Access Compliance Report

Public Rights-of-Way

Intersection ID: 54779	Main Street: INDEPENDENCE/I-277_RA	Cross Street: N_SHARON_AMITY_RD	Location: NW
ADA ID: B6324E35CDD2	Ramp Type: Perp	Initial Pass/Fail: Fail	Overall Compliance: No
Severity Score: 13.75			
Codes/Mitigation Info/Possible Solution		Field Measurements/Component Compliance

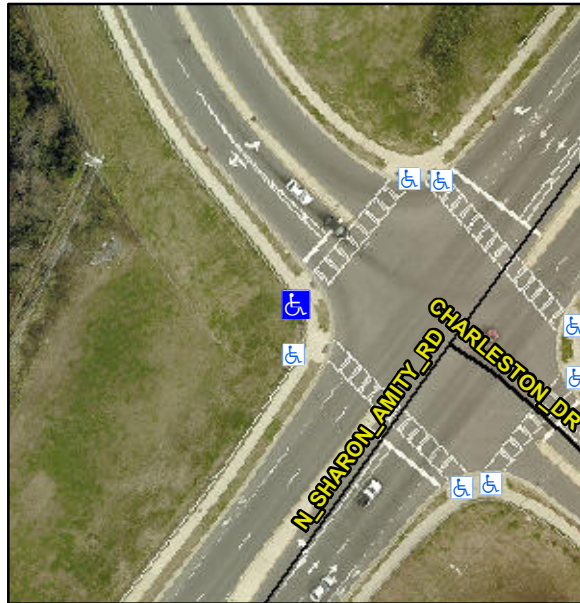
R304.2.2, R304.5.3

Compliance	Description	Data	Compliance	Description	Data
N/A	Ramp Length (in)	65.0	No	Ramp Slope (%)	9.4
Yes	Ramp Width (in)	59.0	No	Ramp XSlope (%)	3.2
N/A	Flare Type LT	N/A	N/A	Flare Type RT	N/A
N/A	Flare Slope LT (%)	N/A	N/A	Flare Slope RT (%)	N/A
N/A	Flare Traversable LT?	N/A	N/A	Flare Traversable RT?	N/A
N/A	Landing Length (in)	N/A	N/A	DWS Provided?	N/A
N/A	Landing Width (in)	N/A	N/A	DWS Contrast?	N/A
N/A	Landing Slope (%)	N/A	N/A	DWS Length (in)	N/A
N/A	Landing X Slope (%)	N/A	N/A	DWS Full Width?	N/A
N/A	Landing Curb? (Y/N)	N/A	N/A	DWS Offset (in)	N/A
N/A	Shared Landing?	N/A			
N/A	Gutter Ponding?	N/A	N/A	Gutter Slope (%)	N/A
N/A	Gutter Lip Ht (in)	N/A	N/A	Gutter X Slope (%)	N/A
N/A	Painted X Walk1?	Yes	N/A	Painted X Walk2?	N/A
	X Walk 1 Direction	To NE		X Walk 2 Direction	N/A
N/A	X Walk 1 Width (in)	111.0	N/A	X Walk 2 Width (in)	N/A
	X Walk 1 Slope (%)	6.8		X Walk 2 Slope (%)	N/A
	X Walk 1 X Slope (%)	2.8		X Walk 2 X Slope (%)	N/A

Remove & Replace Entire Ramp.
